## Outstanding Technical Corrections for Uplands Filing 1, Block 3 Official Development Plan

OFFICIAL DEVELOPMENT PLAN  
**UPLANDS - FILING NO. 1 - BLOCK 3**  
 A PLANNED UNIT DEVELOPMENT  
 IN THE CITY OF WESTMINSTER  
 COUNTY OF ADAMS, STATE OF COLORADO  
 SHEET 46 OF 156

Sheet 1:

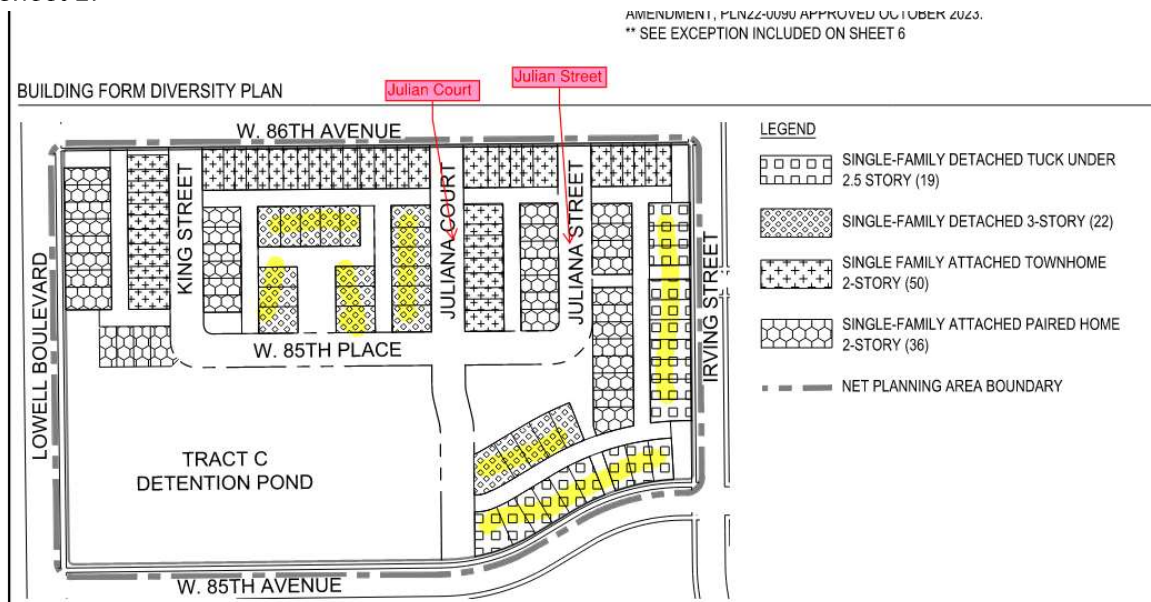
Minimum 2" margin required on left side and minimum 1/2" margin required on all other sides. Typical all sheets.

Sheet 2:

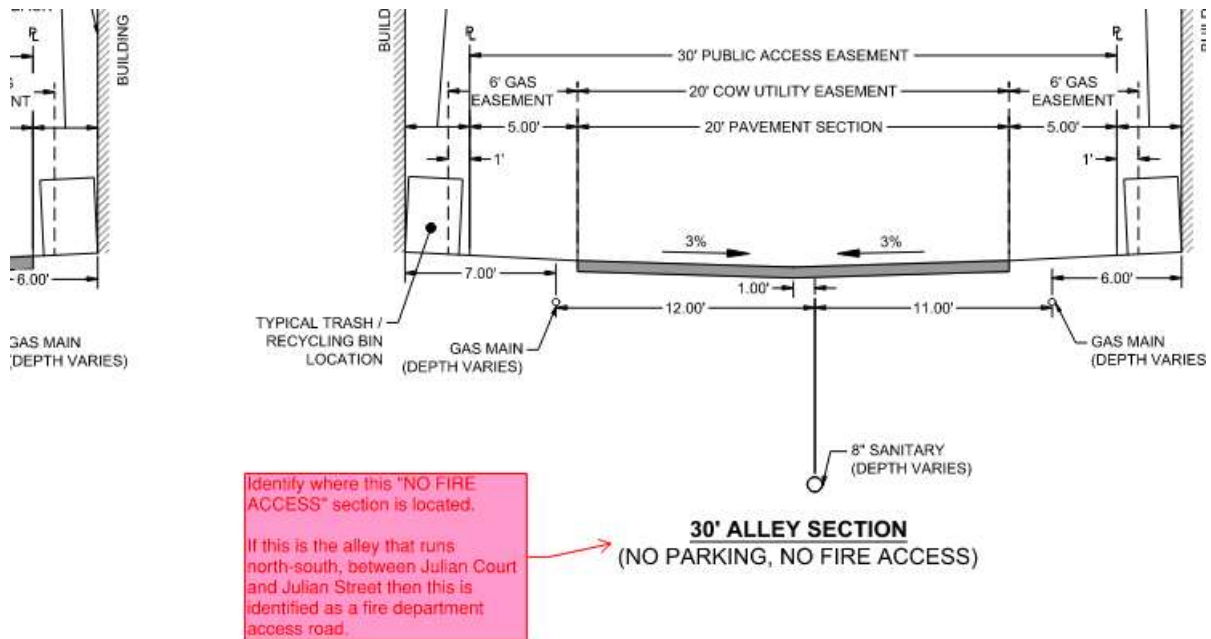
Per pages 25, 26, 27, & 29, details C-C and D-D and various sheets that demonstrate a 26 ft wide fire department access road on the garage loaded sides of the 2.5 tuck-under models - this meets the agreed upon building setbacks and fire department access widths.

Sheet 46:

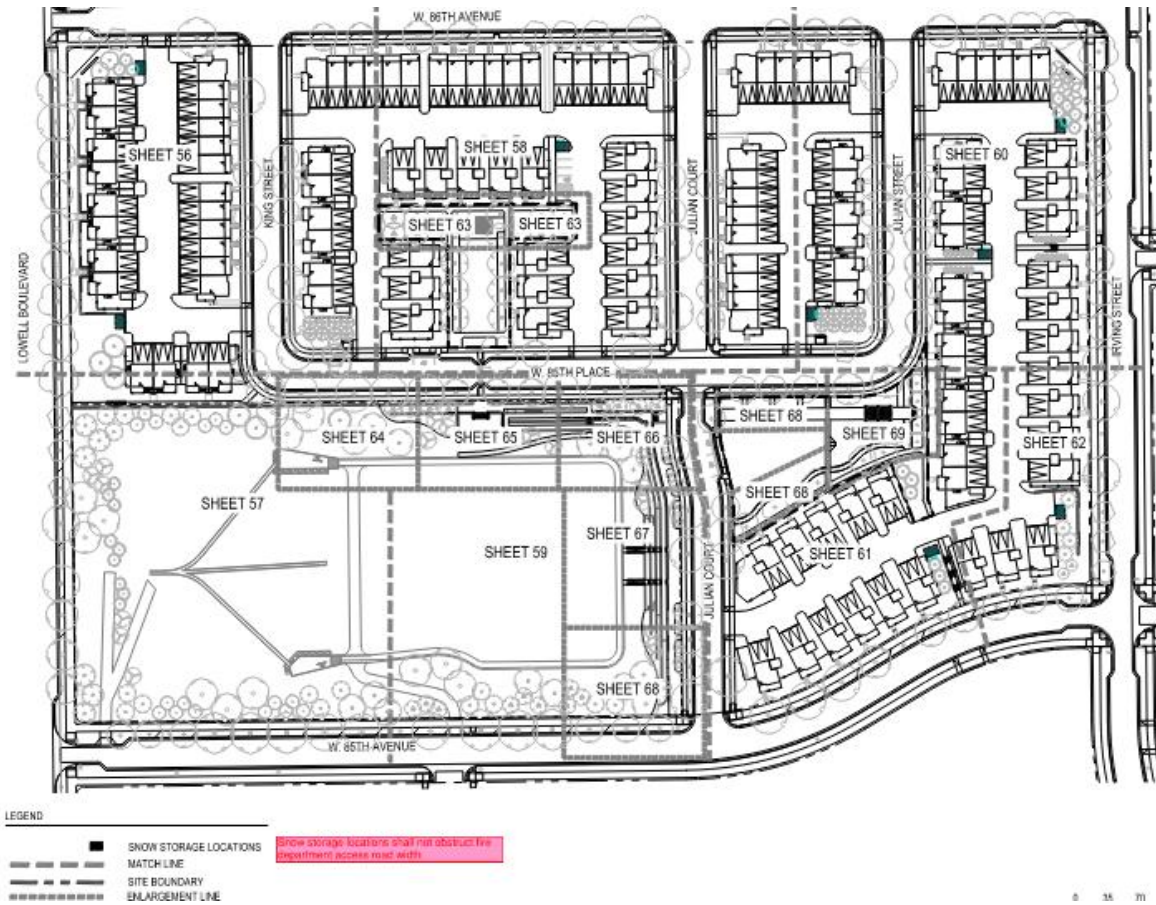
This statement does not match with the list of homeowner responsibilities on Sheet 7. Please clarify or fix this note to clearly delineate maintenance responsibilities.

Add (tree levels)  
 This language should match the language used on sheet 7 to avoid confusion.

Sheet 55:

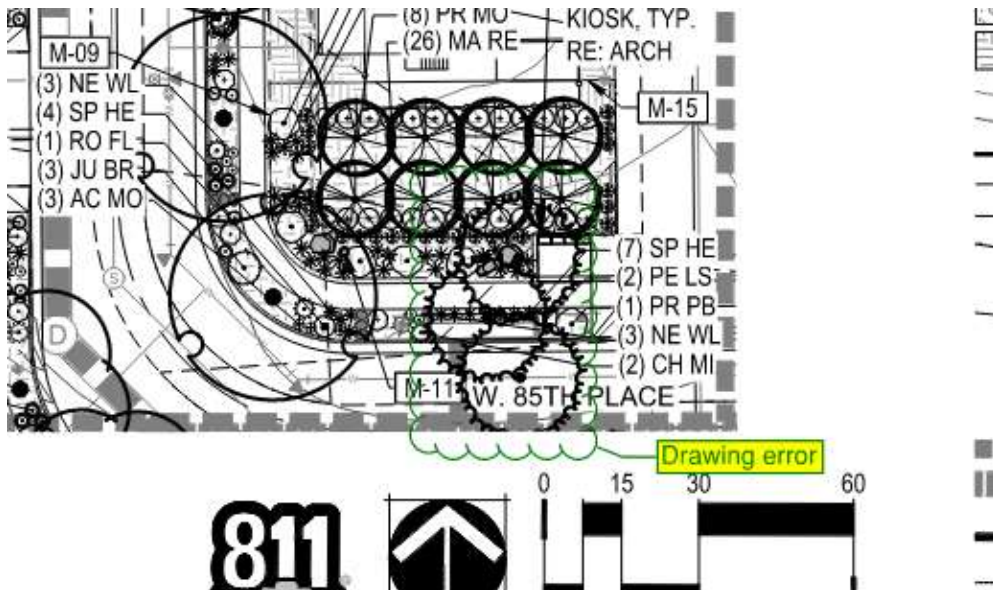
A 3-ft clear space shall be maintained around the circumference of fire hydrants. Unobstructed access to fire hydrants shall be maintained at all times. The fire department shall not be deterred or hindered from gaining immediate access to fire protection equipment or fire hydrants.
